Rezoning Transportation Analysis

Petition Number: 2023-027

General Location Identifier: 12506201, 12506202

Date	Description
06-28-23	First Review (PDM)

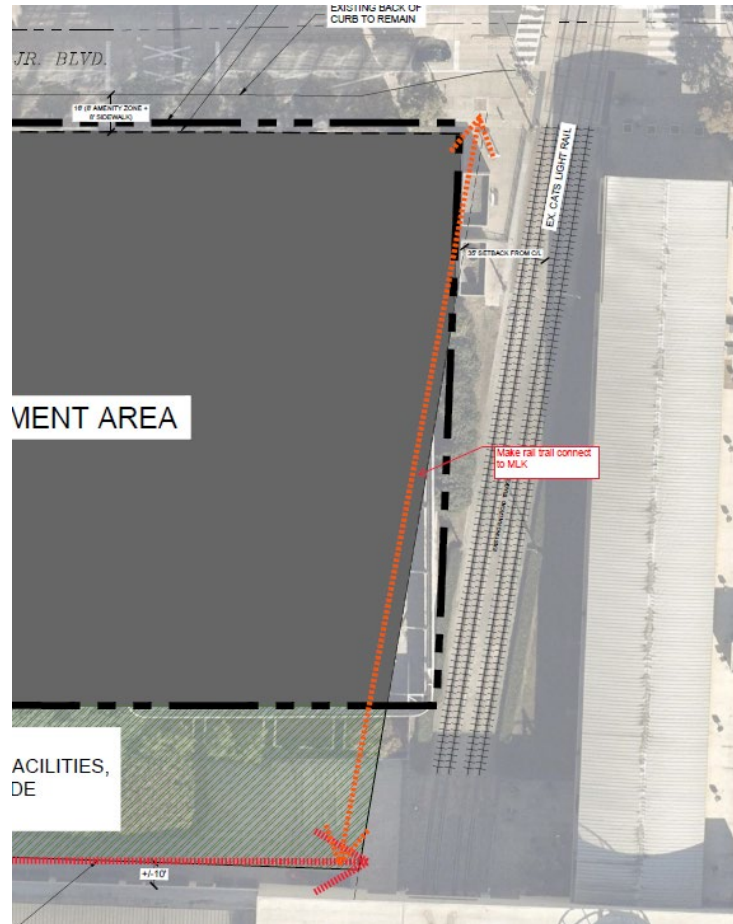
8. Add a conditional note specifying “the Petitioner shall dedicate and convey in fee simple all rights-of-way to the City before the site’s first building certificate of occupancy is issued. CDOT requests rights-of-way set at 2’ behind back of sidewalk where feasible.”
9. Add a conditional note specifying “All transportation improvements will be approved and constructed before the site’s first building certificate of occupancy is issued. The petitioner may phase transportation improvements if said improvements and phasing are explicitly described in site plan notes.”
10. Revise site plan to add more clarity to the area below that is outside of the property line but part of the rezoning. Is this public ROW?
